ADDENDUM NO.1 TO THE MASTER DRAINAGE REPORT FOR SILVERSTONE

February 13, 2014

ADDENDUM No.1

COS # 425-SA-2006 #15-ZN-2006, 124-NP-2006, PC# 3476-06-2

PLATE 3

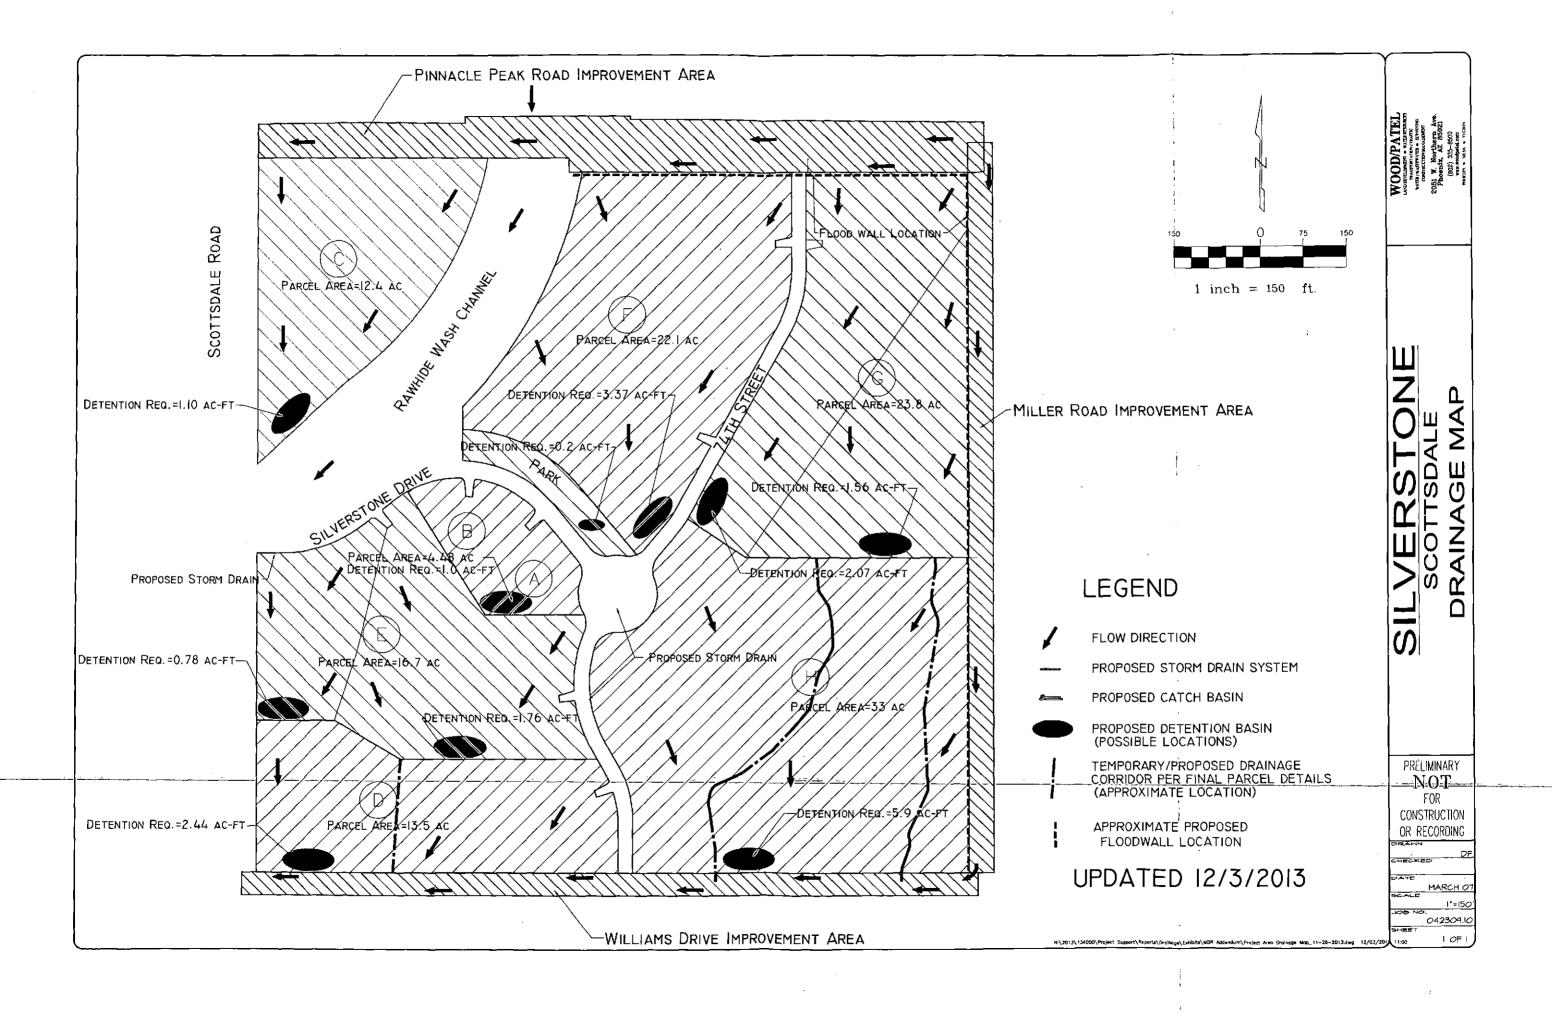
- Revisions to the Master Drainage Report (MDR) are as follows:
 - o Table 4.1 Parcel Detention Requirements is revised as shown below:

Parcel 1 Basin	Tributary Area	Weighted runoff coefficient	Required Volume	Required Volume
	ac		cf	ac-ft
A&B*	4.5	0.9	41274	0.95
С	12.35	See Appendix B	47766	1.10
D**	13.5	0.9	106291	2.44
E**	16.7		-111033-	2:54
F**	22.1	0.76	146936	3.37
G**	23.8	0.76	158239	3.63
H*	32.8	0.76	254867	5.85
Park*	1.9	0.33	6998	0.16

- ** Required detention volumes for these parcels are updated based upon updated rainfall depth data. Recent changes in C.O.S. stormwater storage policy for previously developed sites may allow for a reduction in required storage volume, but this reduction was not explored for these parcels in this addendum.
 - Plate 3 Silverstone Drainage Map, which displays possible locations of proposed detention basins, is revised. The revised plate is attached and dated December 3, 2013.
- Additions to MDR are as follows:
 - o Appendix B is added to the MDR and includes the following:
 - Table B1 Parcel C Required Stormwater Detention Volume
 - Table B2 Parcel C Pre-Existing Condition Weighted Runoff Coefficients
 - Table B3 Parcel C Post-Developed Condition Weighted Runoff Coefficients
 - Exhibit 1 Pre-Existing Condition Map
 - Exhibit 2 Post-Developed Condition Map

SILVERSTONE
PARCEL C
1 - PRE-EXISTING CONDITION

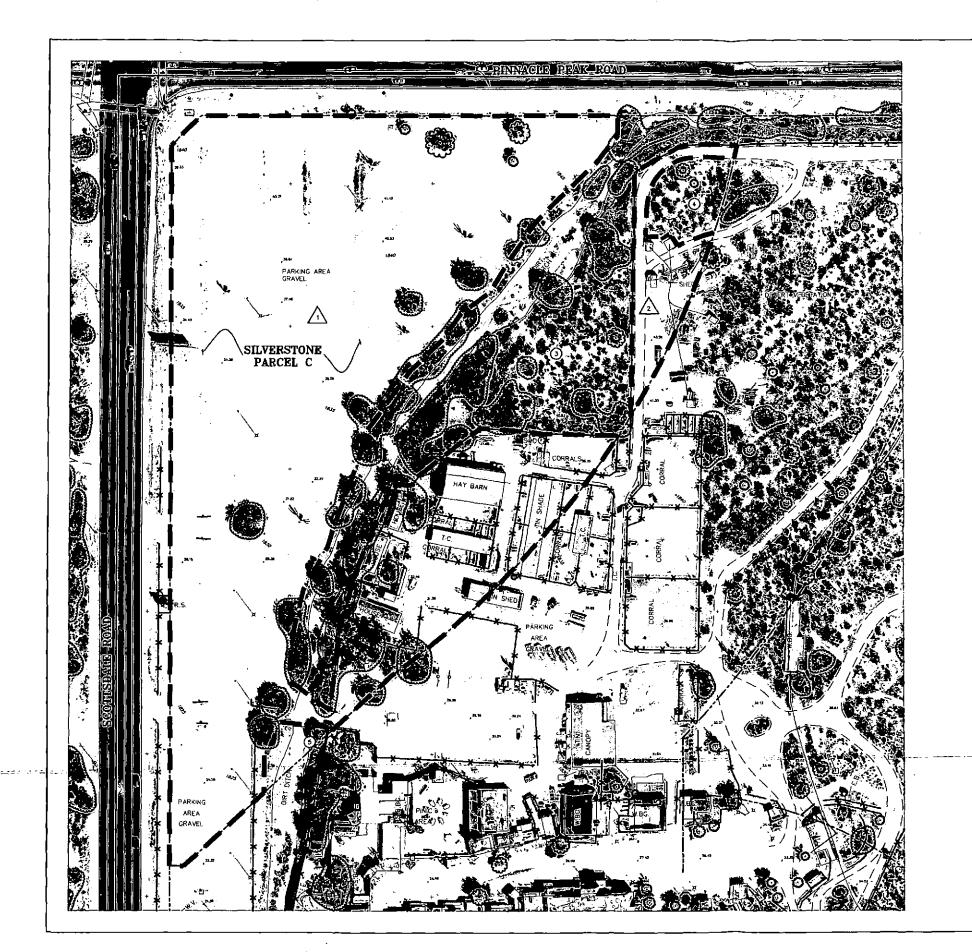
4. Refer to Exhibit 1 - Pre-Existing Condition Map and Exhibit 2 - Post-Developed Condition Map for area delineation.

- 1. Refer to Exhibit 1 Pre-Existing Condition Map for area delineation.
- 2. Surface type and associated C value per Figure 4.1-4 Runoff Coefficients for use with Rational Method of the C.O.S. Design Standards and Policies Manual.
- 3. For pre-existing compacted gravel parking areas and dirt/gravel pathway areas a C value equivalent to the C.O.S. C value for desert landscaping is utilized.
- 4. C values are not reported for pre-existing undeveloped areas.
